WorleyParsons Komex

Re: Review of Olin First Quarter 2006 Groundwater Monitoring Report.

On behalf of the City of Morgan Hill (City), WorleyParsons Komex has reviewed the report by Olin Corporation (Olin) titled "First Quarter 2006 Groundwater Monitoring Report, Olin/Standard Fusee Site, 425 Tennant Avenue, Morgan Hill, California" (the Report). Our review focused on the components of the report related to the northeast flow situation wherein perchlorate from the Olin/Standard Fusee site (the Site) has impacted the municipal water supply of the City of Morgan Hill ("City"). Our review does not reference the various other potential perchlorate sources which at this time have not been shown to either exist, impact groundwater (in particular the Deep Aquifer), or impact any well operated by the City. In particular we reviewed in detail Appendix E, Northeast Groundwater Flow Assessment – Update (Appendix E). The main findings of our review are discussed below. For reader convenience, cited figures from the Report are included in **Attachment A** of this document.

FIGURE
E20

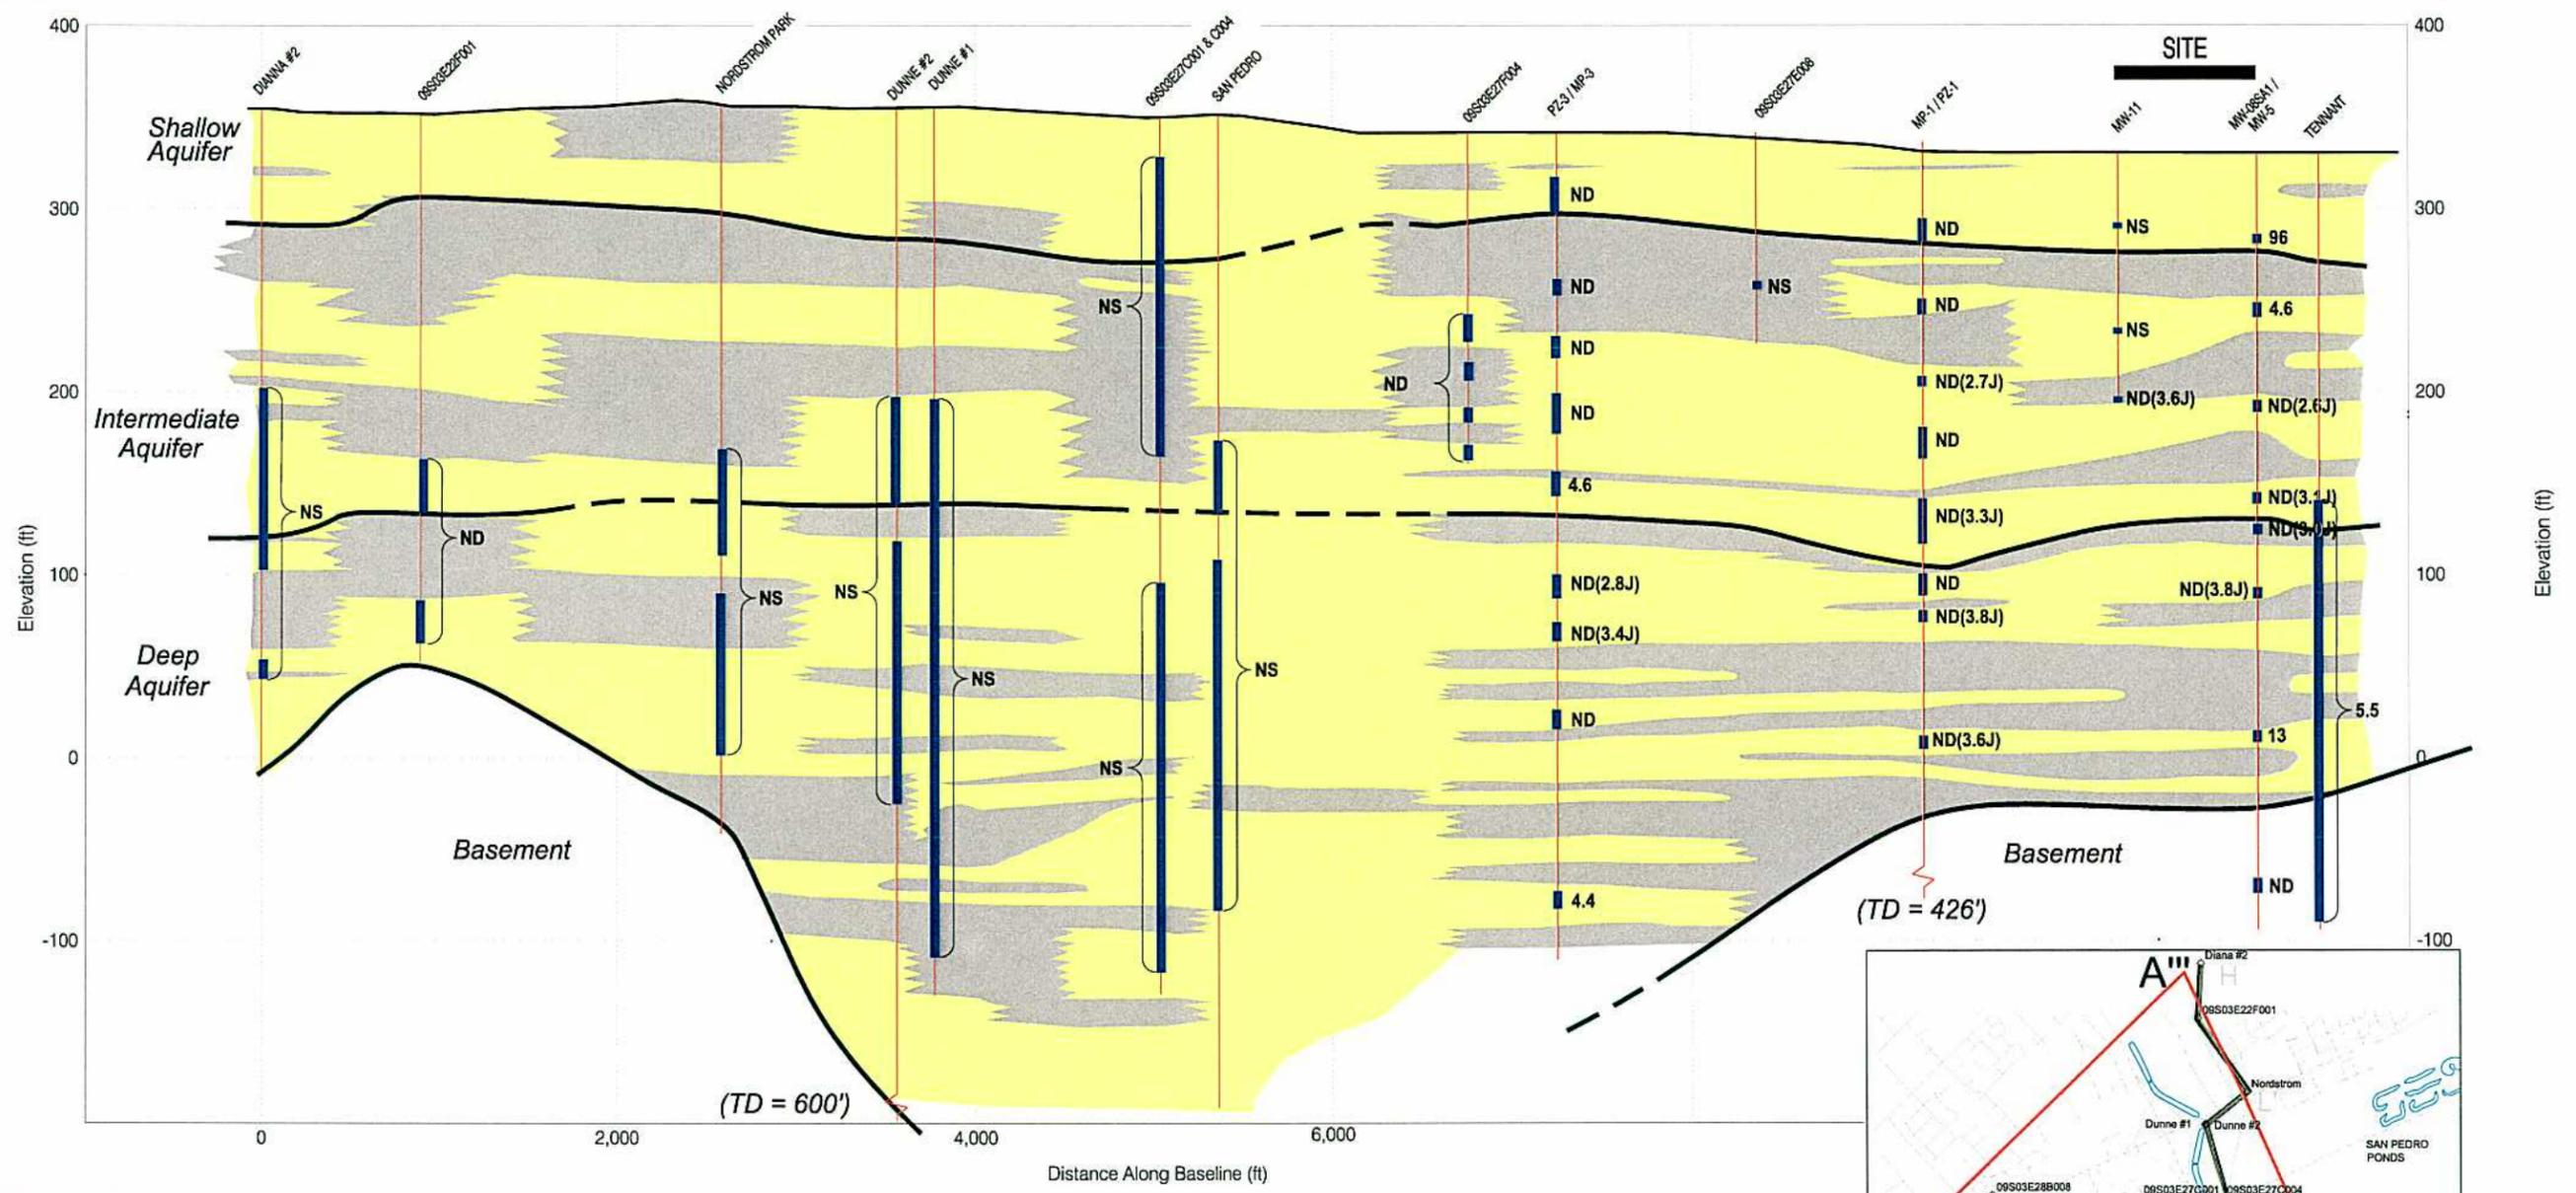
- As shown in the north-south cross section, Figure E20, major aquifer units to the Northeast of the Olin Site are relatively horizontal, and generally laterally continuous. Consequently, the elevation of the screened interval mid-point of the City's wells can be used as a check on whether a well is being appropriately included in mapping of groundwater elevations. In the Middle Deep Aquifer zone, as mapped in Figure E5b, the Olin wells and piezometers to the northeast of the site have screen midpoint elevations within a 35 foot interval, ranging from 2.06 ft above mean sea level (MSL; PZ-01-333) to 37.38 ft MSL (MP-04-291). City wells whose screened interval mid-points fall in this range include Dunne #1 (37.88 ft MSL), San Pedro (38.07 ft MSL), and Tennant (22.85 ft MSL). All other city wells except Condit (45.59 ft MSL), are completed at substantially higher elevations (in terms of screened interval mid-point), for example, Dunne #2 (87.93 ft MSL) and Nordstrom Park (94.56 ft (MSL). The screened interval midpoint elevations of the
